MEMORANDUM –

SUBJECT: Setdown Report for Z.C. 07-21 B
Major Modification to an Approved Consolidated Planned Unit Development
2201 M Street, N.W. (formerly known as 2213 M Street, NW)

ATTACHMENTS: COMPARISON OF APPROVED AND PROPOSED DESIGNS OF 2201 M STREET, NW

6. Ground Level Plan

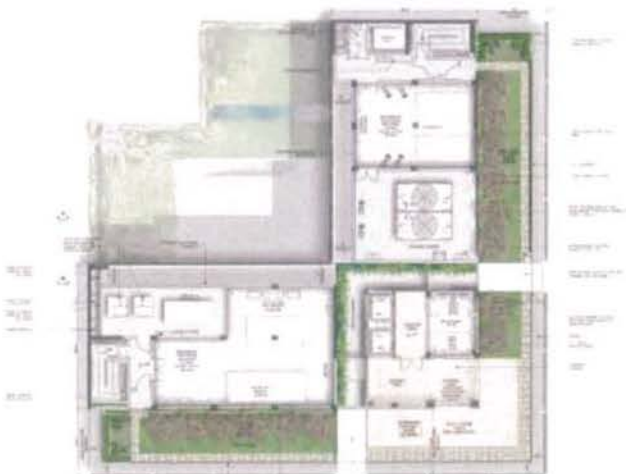
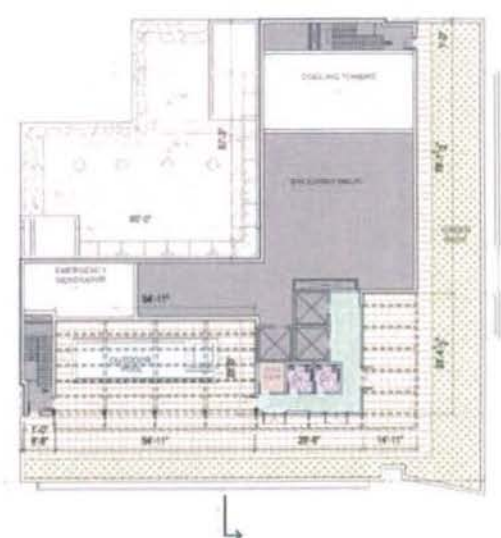
- §633 Ground Level Public Space Requirements: The ground level development in the CR zone is required to provide "the equivalent of ten percent" of the total lot area for public space. It is to be adjacent to the main entrance, open to the public on a continuous basis and open to the sky or have a have a minimum vertical clearance of 10 feet. The applicant received complete relief from this. In lieu of the open space, the approved PUD was to locate a restaurant on the building's prime corner, design it to be open to the street when weather permits; encourage public use of the lobby, lounges, garden and other facilities on the ground floor and second levels, make the roof deck open to the public and promote public education about the building's environmentally sustainable elements.

The proposed modification would contain all of the alternate features, albeit without a publicly accessible roof deck - which would be replaced by an outdoor rooftop pool reserved for hotel guests -- and with the approved 3855 square foot restaurant being resized to 3662 square feet.
